Modification of the powerplant – ignition unit to Ducati 432372501 ignition electronic boxes

Revision 1: 12. February 2010

Picture 2

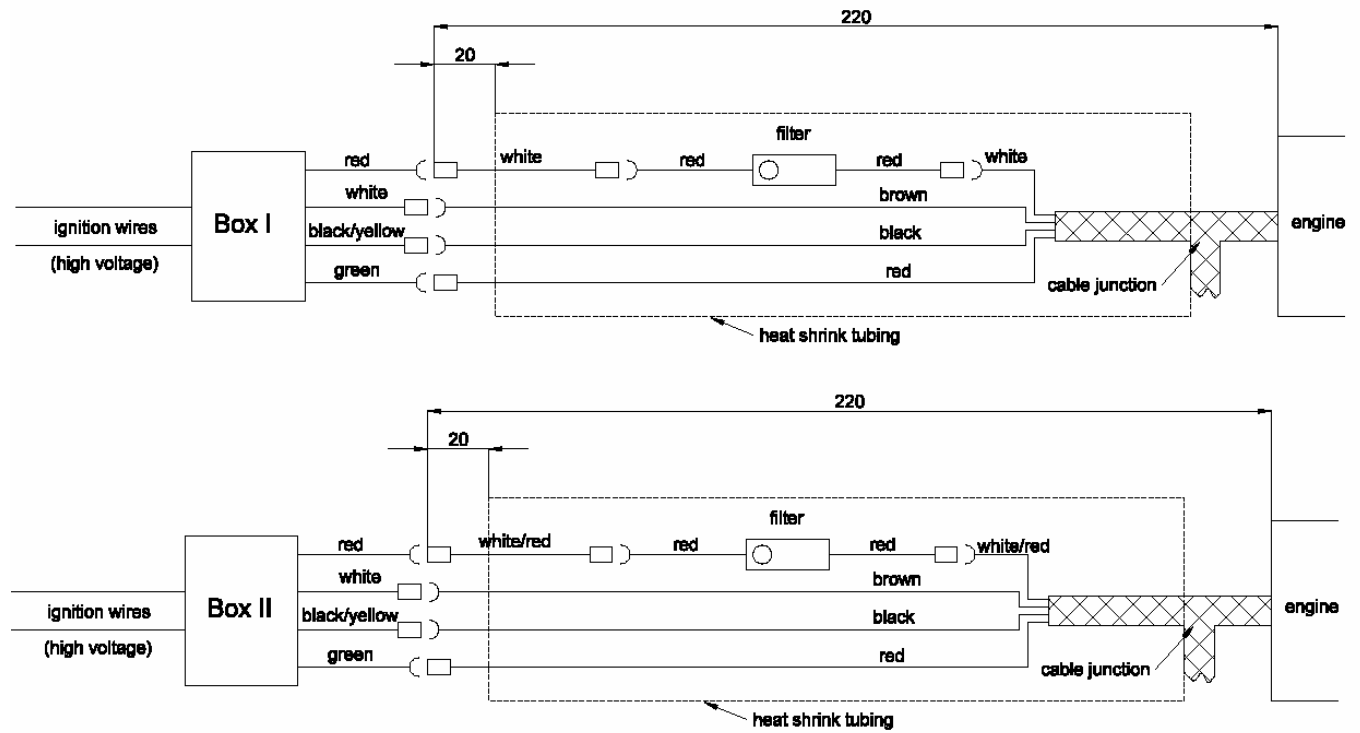
2. Cut the white and the white/red wire 40 mm (sketch 2 detail Z) in front of the junction of the cable harness (pic.2). Slip pieces of heat shrink tubing over the shortened wires, crimp one spade connector (female) to each of the wires and shrink the tubing.

3. Plug an ignition box filter (pict. 1) to each of the two cable shoes. Slip heat shrink tubing over the connections and shrink the tubing. Take care of the correct mounting direction. (see pict.2).

4. Crimp a spade connector (male) on each of the wires remaining from point 2. Connect the wires according to pict.2 to the filters, so that you have the same wire colours as on the other side of the filter.

5. The cable harness for the ignition box aft (BOX II) has to be shortened to 300mm (pic.2). The cable harness for the front ignition box (BOX I) has to be shortened to 220mm (sketch 2 and pic.2). Slip heat shrink tubing over the cable harness as indicated in picture 2 and shrink the tubing. Note: 20mm of the wires must not be covered by the heat shrink tubing see pict.2.

6. Crimp cable shoes to the wires according to pict.2
7. Connect the wires to the ignition boxes according to pict.2.
8. Slip heat shrink tubing over every connection.

Sketch 1

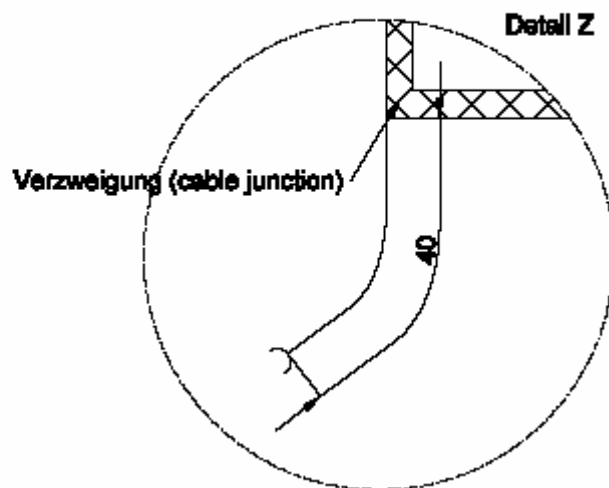
11. Move the Bowden cable mounting 4R38/1 60 mm from the original position to the position (see sketch 1). This must be done even when Ducati boxes have already been installed.

Sketch 2

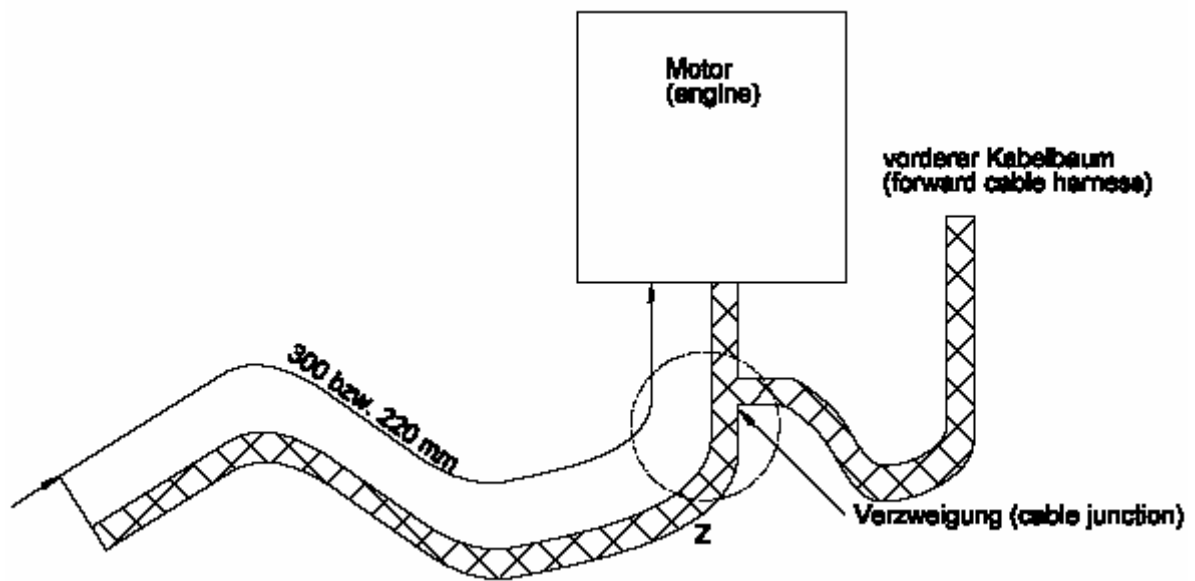
1. Open the cable harness from the ignition boxes up to the cable junction (pic.2 and sketch 2). The wires coloured white, brown, black and red are for ignition box 1 and white/red, brown, black and red are for ignition box 2.
